Access Compliance Report

Public Rights-of-Way

Intersection ID: 13086	Main Street: CENTRAL_AV	Cross Street: CLEMENT_AV	Location: NW
ADA ID: A08E156E938C	Ramp Type: Directional1	Initial Pass/Fail: Fail	Overall Compliance: No
Severity Score: 12.5

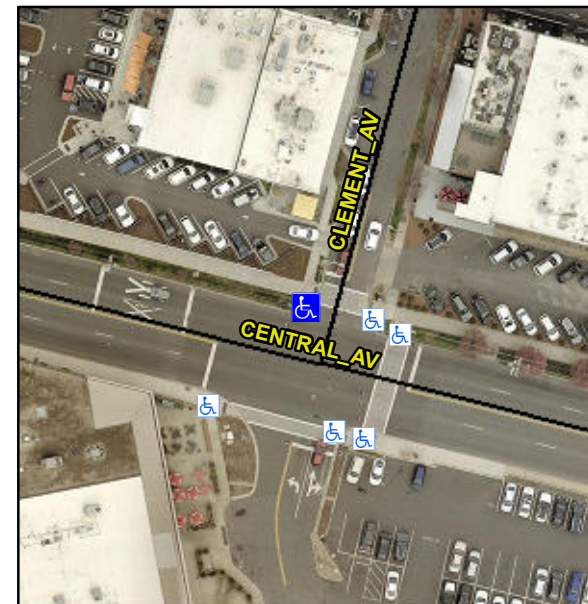
R304.2.2

Compliance	Description	Data	Compliance	Description	Data
N/A	Ramp Length (in)	43.0	N/A	Grade Break?	N/A
Yes	Ramp Width (in)	62.0	N/A	Grade Break Slope (%)	0.0
No	Ramp Slope (%)	9.9	N/A	Grade Break XSlope (%)	0.0
Yes	Ramp XSlope (%)	1.5			
N/A	Flare Type LT	N/A	N/A	Flare Type RT	N/A
N/A	Flare Slope LT (%)	N/A	N/A	Flare Slope RT (%)	0.0
N/A	Flare Traversable LT?	N/A	N/A	Flare Traversable RT?	N/A
N/A	Landing Length (in)	0.0	N/A	DWS Provided?	N/A
N/A	Landing Width (in)	0.0	N/A	DWS Contrast?	N/A
N/A	Landing Slope (%)	0.0	N/A	DWS Length (in)	N/A
N/A	Landing X Slope (%)	0.0	N/A	DWS Full Width?	N/A
N/A	Landing Curb? (Y/N)	N/A	N/A	DWS Offset LT (in)	N/A
N/A	Shared Landing?	N/A	N/A	DWS Offset RT (in)	N/A
N/A	Gutter Ponding?	0.0	N/A	Gutter Slope (%)	N/A
N/A	Gutter Lip Ht (in)	0.0	N/A	Gutter X Slope (%)	N/A
N/A	Painted X Walk1?	Yes		Road Slope (%)	6.7
	X Walk 1 Direction	To E		Road X Slope (%)	3.6
	X Walk 1 Width (in)	121.0		Clear Space?	N/A

Remove & Replace Entire Ramp.
